OCAN070302

July 3, 2003

Subject: Arkansas Nuclear One - Units 1 and 2  
Docket Nos. 50-313 and 50-368  
License Nos. DPR-51 and NPF-6  
NRC Triennial Fire Protection Inspection Report 01-06; EA-03-016  
Significance Determination Process Report

Figure 10: Selected heat release rate profile for cabinet fires in switchgear room 99M.

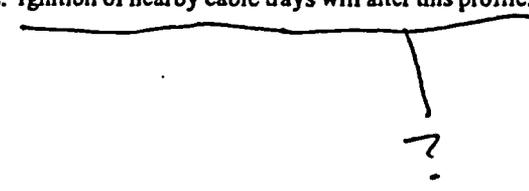
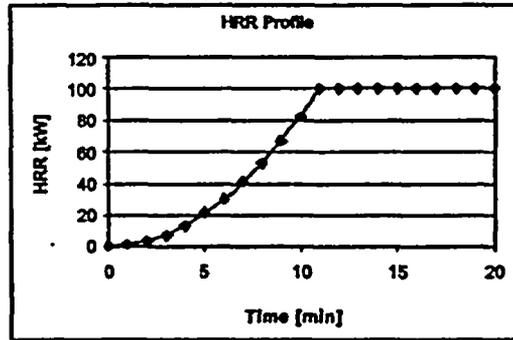
One 4 kV?  
100kW peak in 12min  
80 min for 8min

is NUREG  
4527 correct?

*is the EPRI model correct?*

Figure 14: CFAST results for upper layer and heat release rate in scenario 1a.

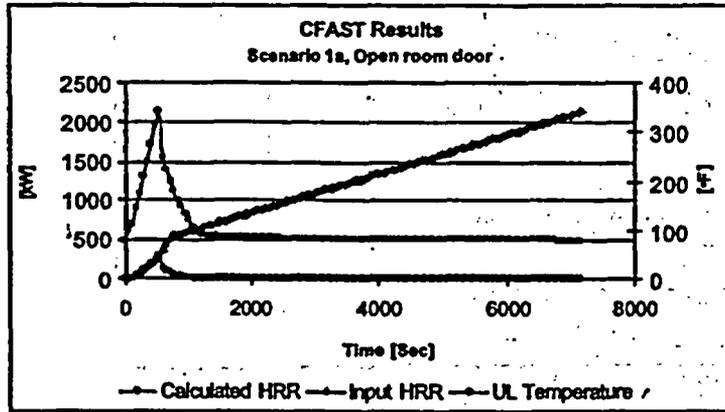
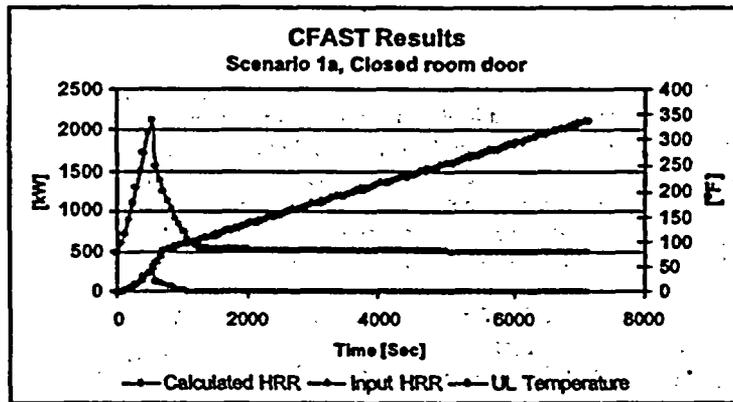
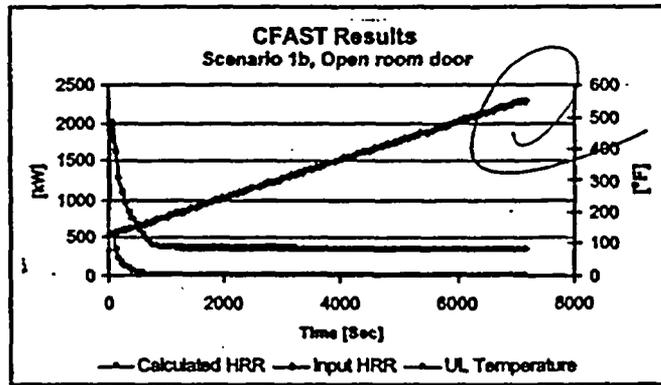
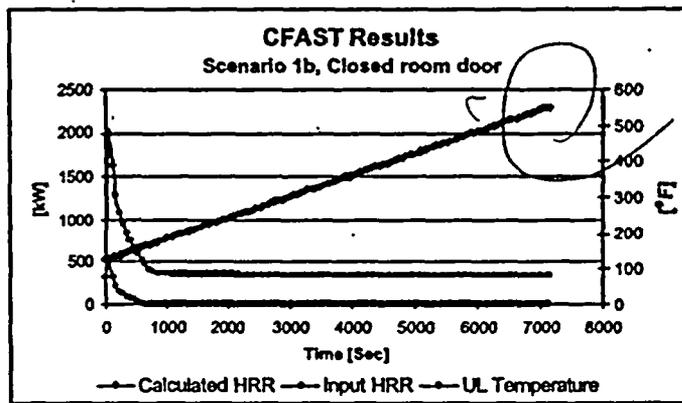
?? N/A stated  
 other models would reach > 700 °F. what  
 is going on?

*Does this mean the fire puts itself out before the fire brigade shows up?*
